**ADDENDUM NO. 06**

**Date: 08.16.2024**

**Westfield Washington School Corporation  
Westfield Middle School West  
Bid Package 02, BI:02 Building Concrete Work and BI:03 Steel and Railing Work  
17707 Centennial Road,  
Westfield, IN. 46074**

This Addendum #06, Dated 08.16.2024, forms part of the contract documents and modifies the original Bidding Documents Dated 07.26.2024. Please acknowledge receipt of this Addendum in the space provided on the Bid Form. Failure to acknowledge this Addendum may subject the Bidder to disqualification.

DRAWING NUMBER  
A455

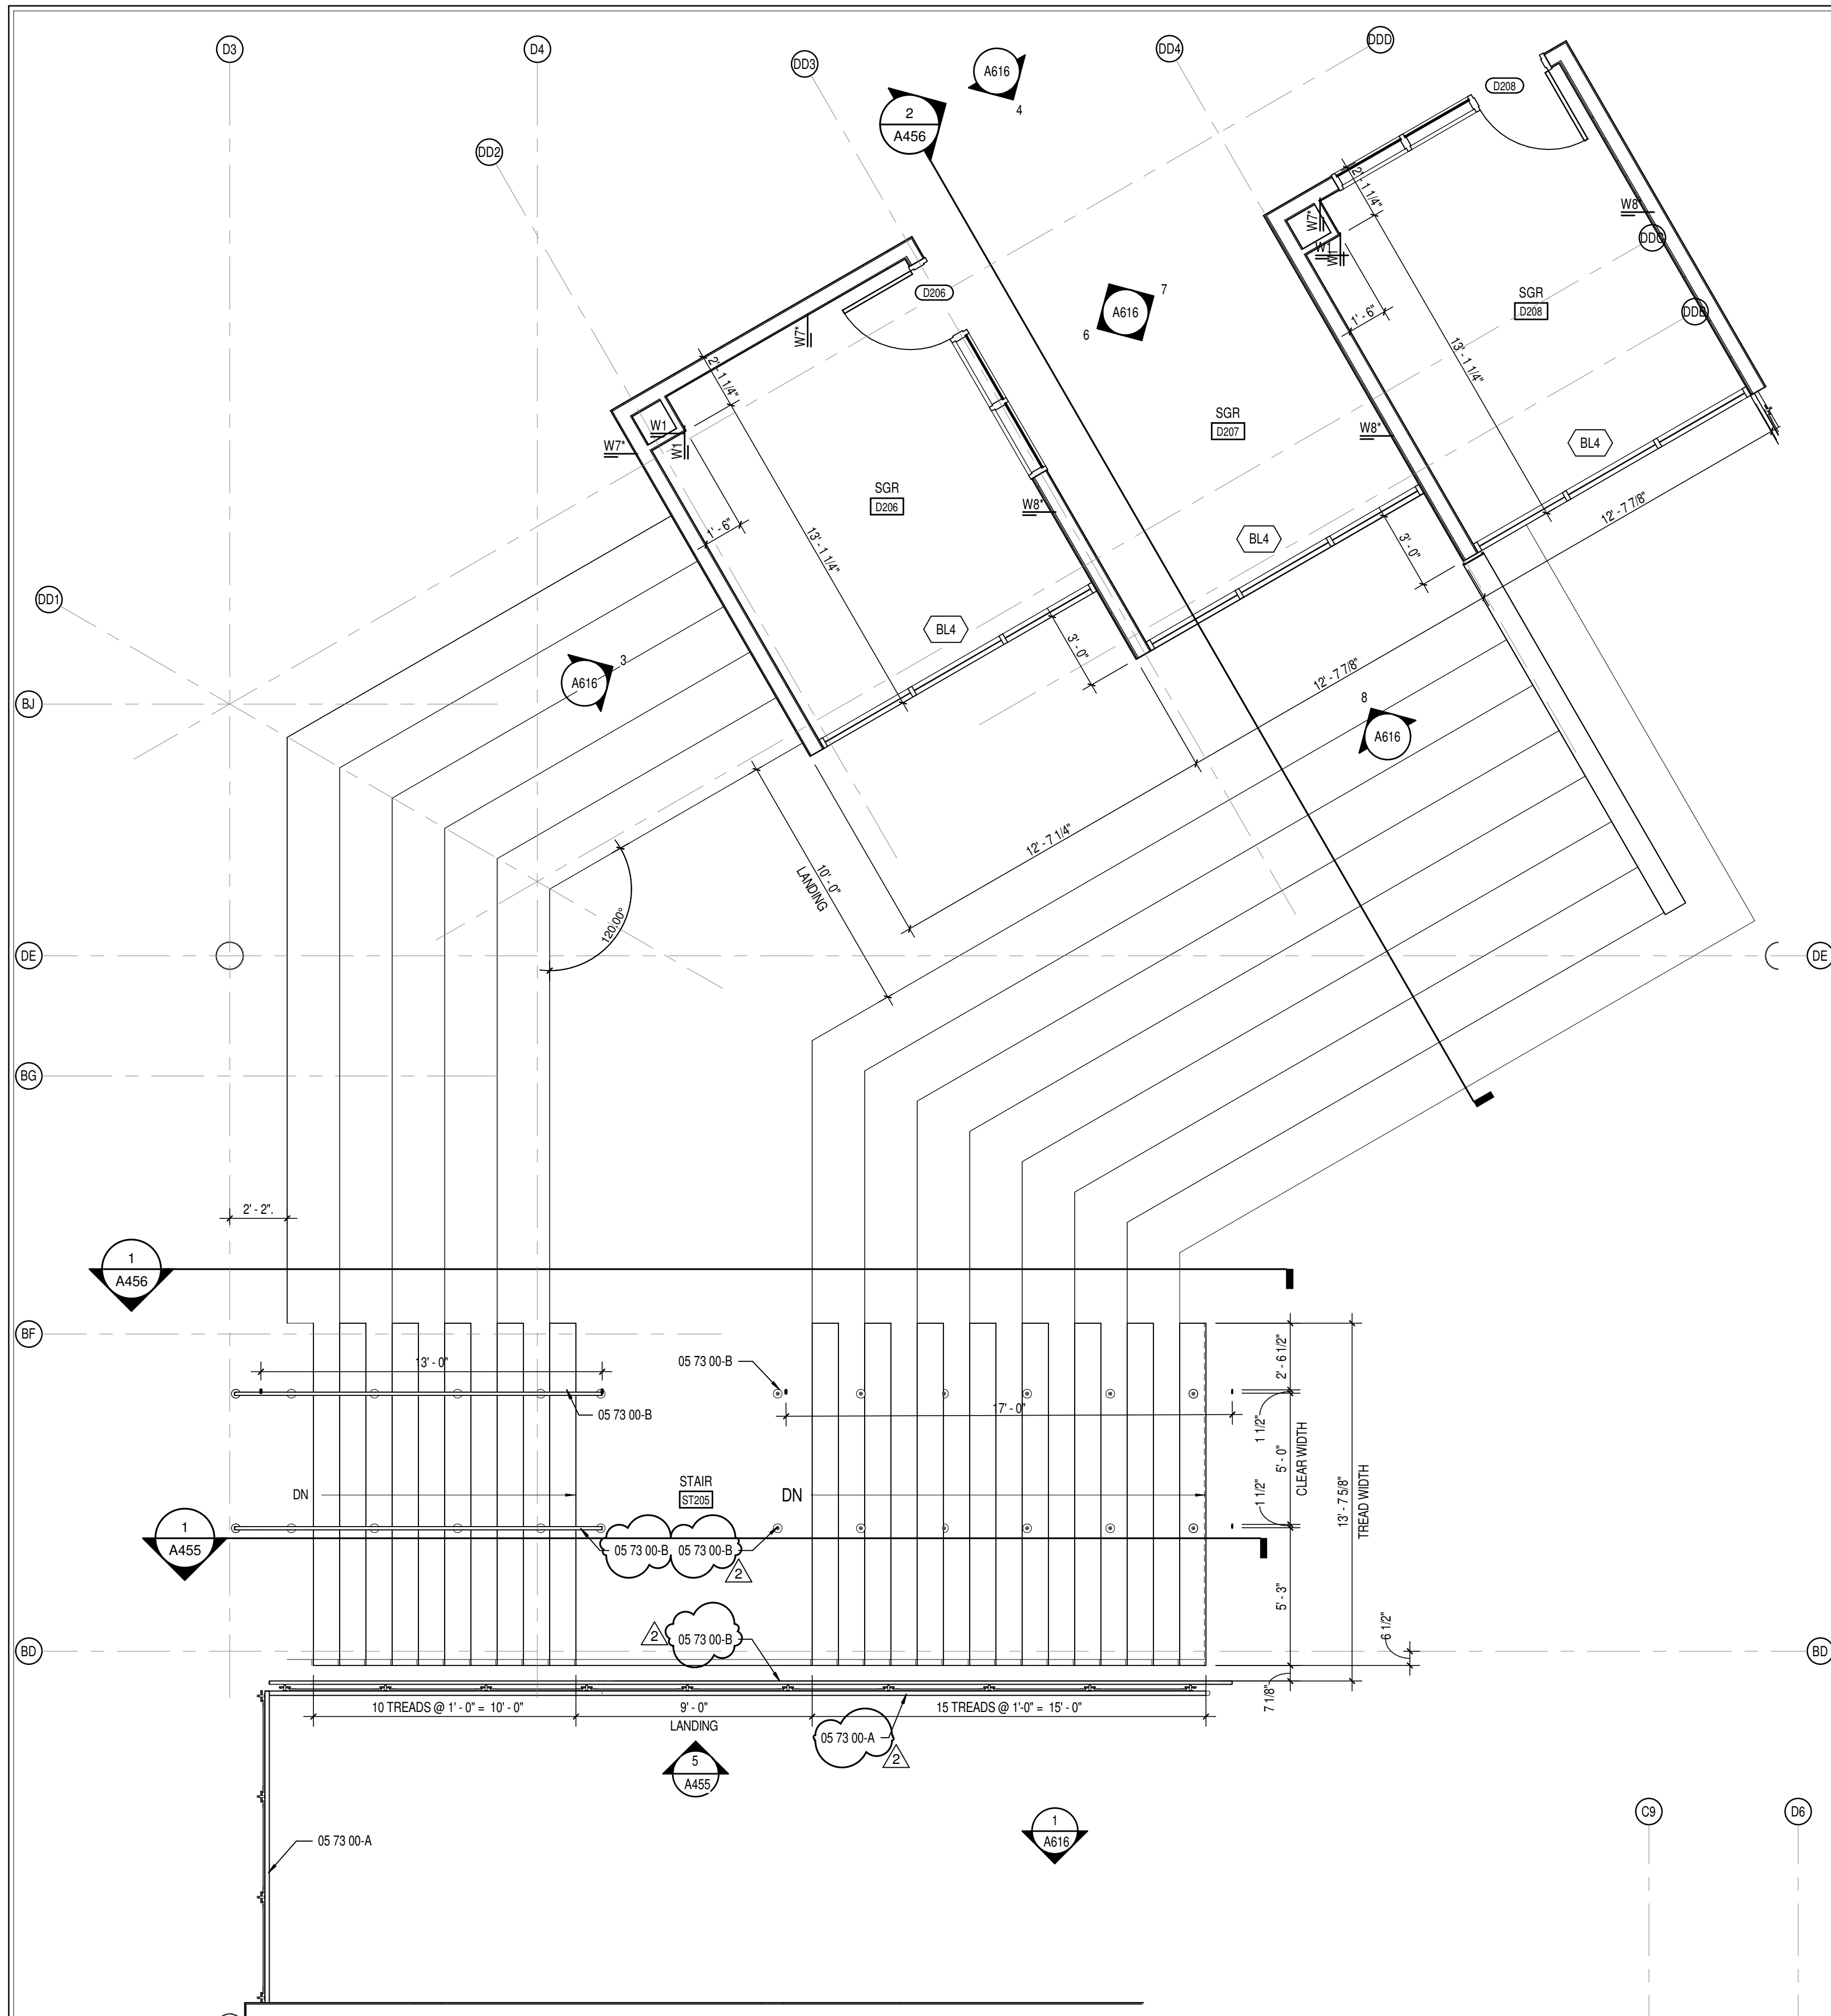
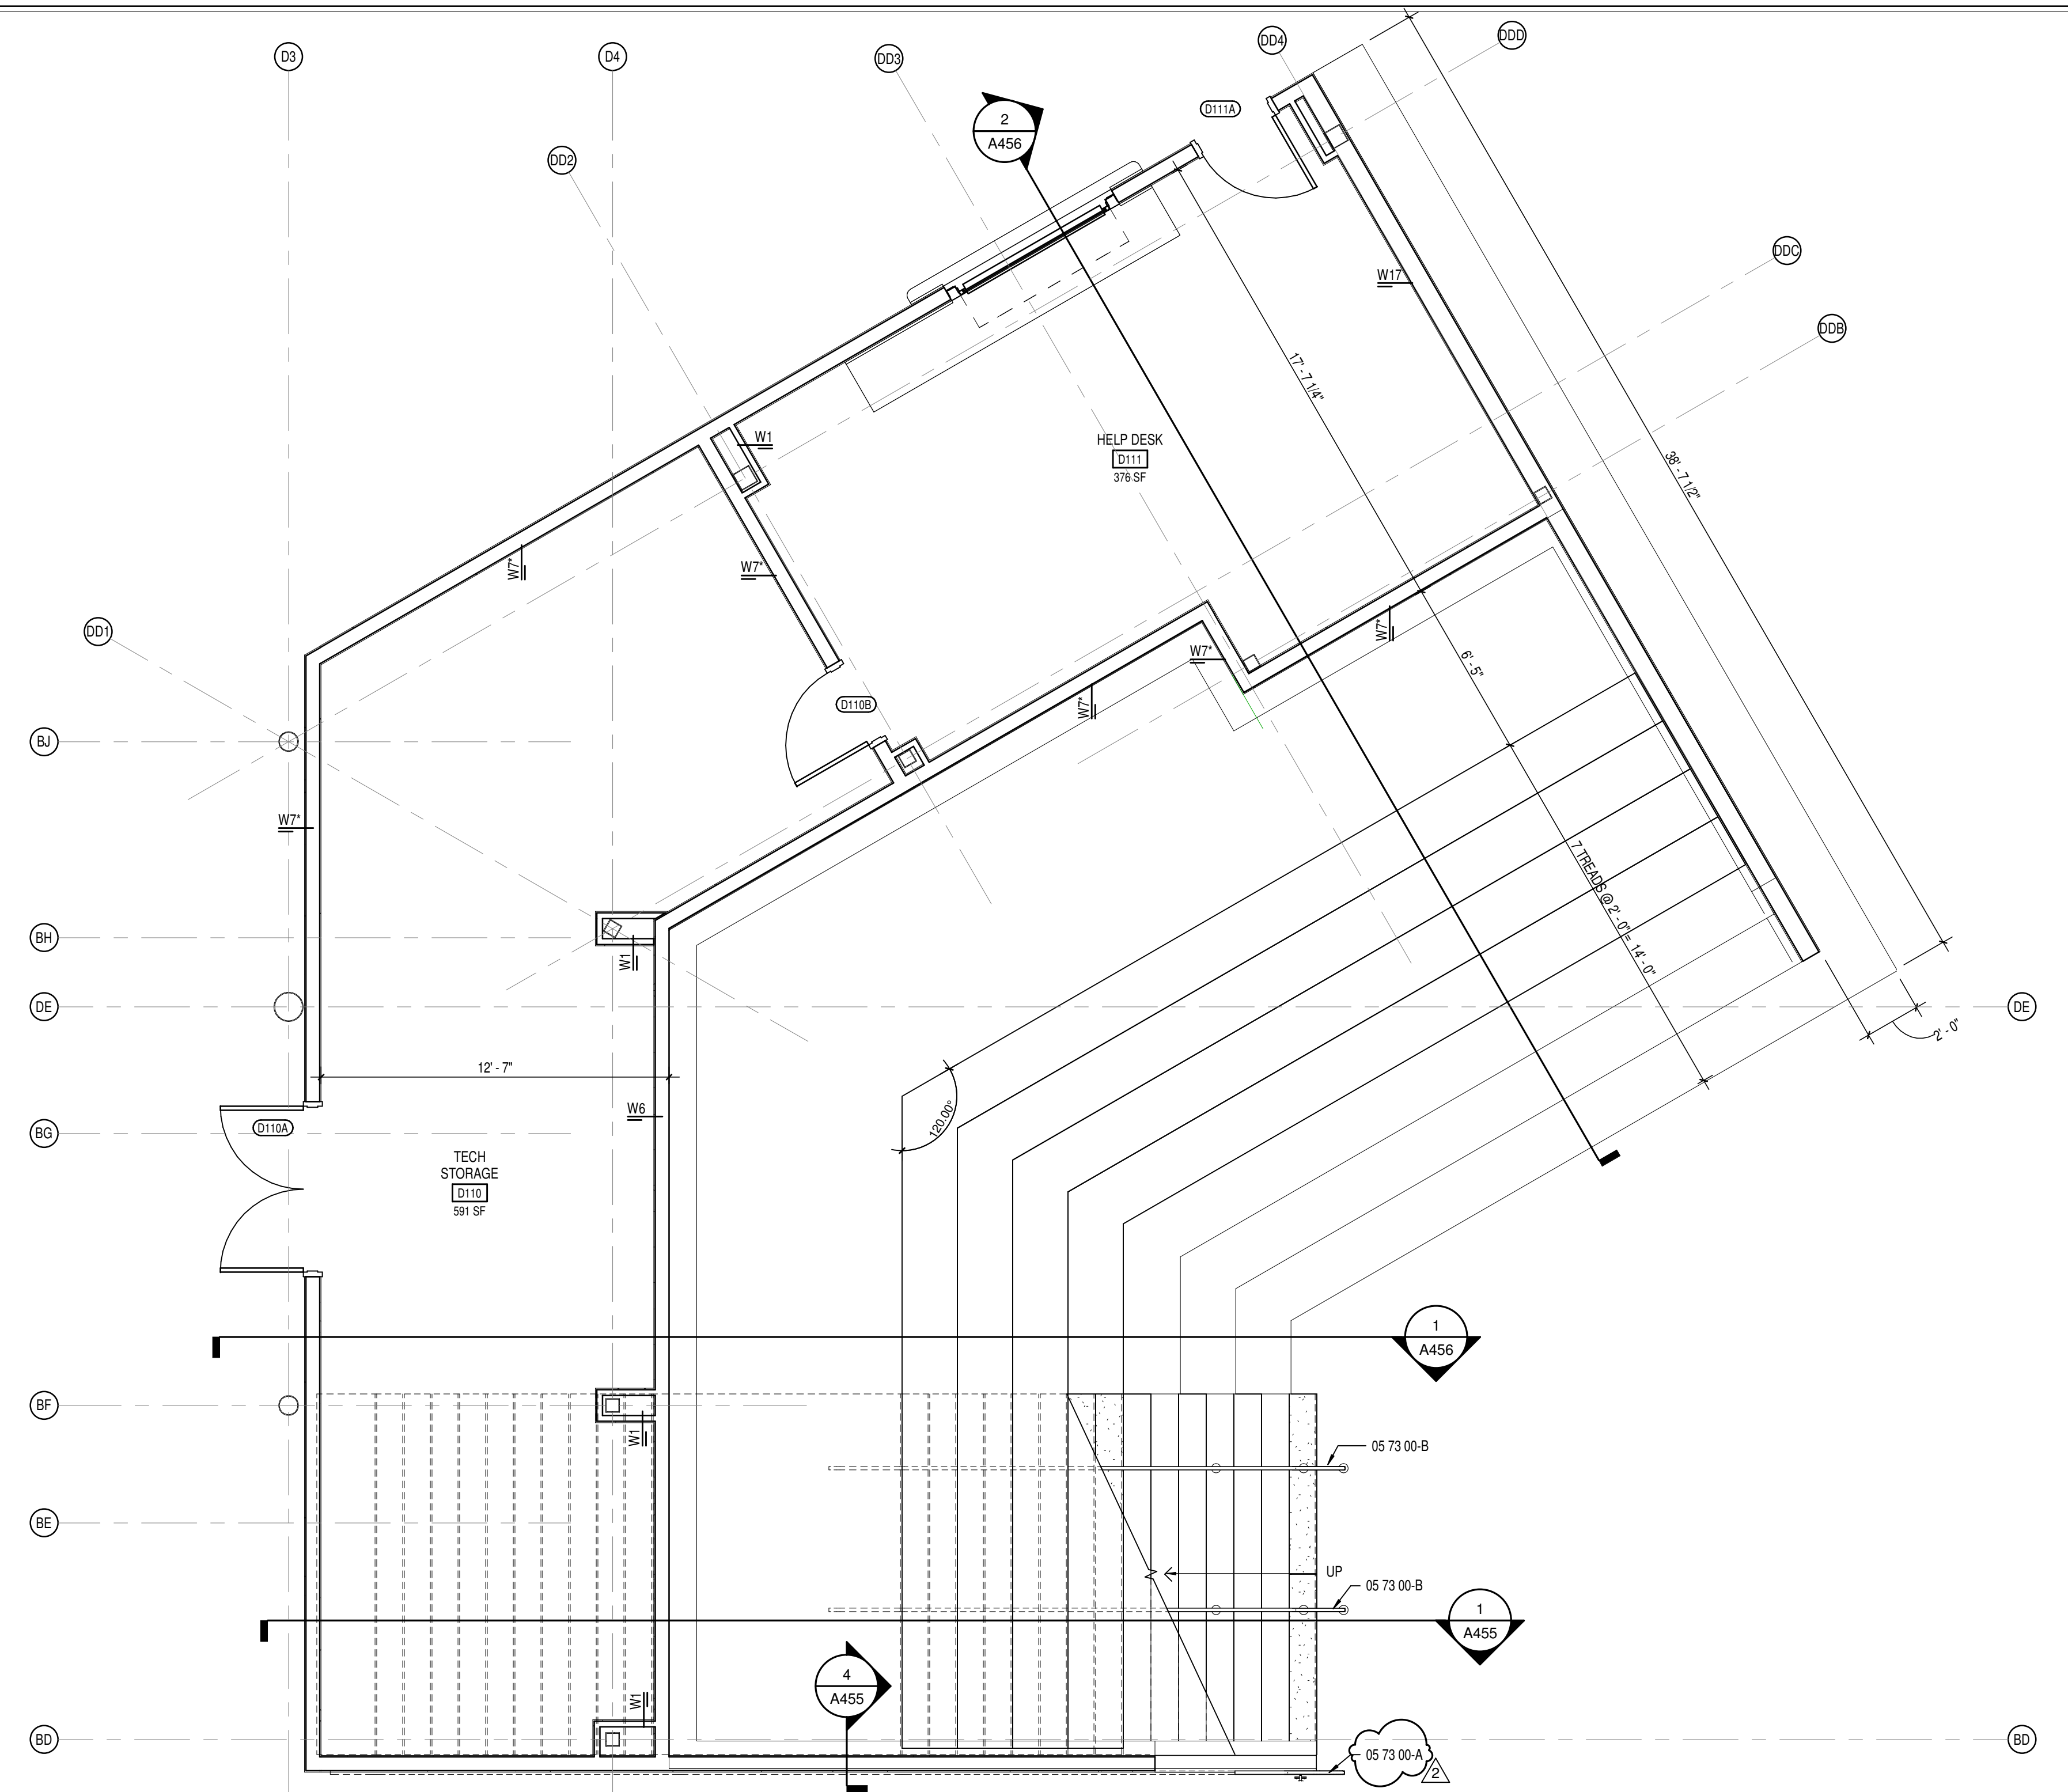
10. Bid Item #02 Building Concrete Contractor shall furnish and install the Stair Nosings per Spec Section 05 55 16 to the Stair per the Detail 1/A455.

A. Detail 1/A455 - STAIR ST105 SECTION B- SOUTH

B. Detail 2/A455 – STAIR ST105 ENLARGED GROUND FLOOR PLAN

C. Detail 3/A455 – STAIR ST105 ENLARGED SECOND FLOOR PLAN

D. Detail 4/A455 – ENLARGED RAILING DETAIL
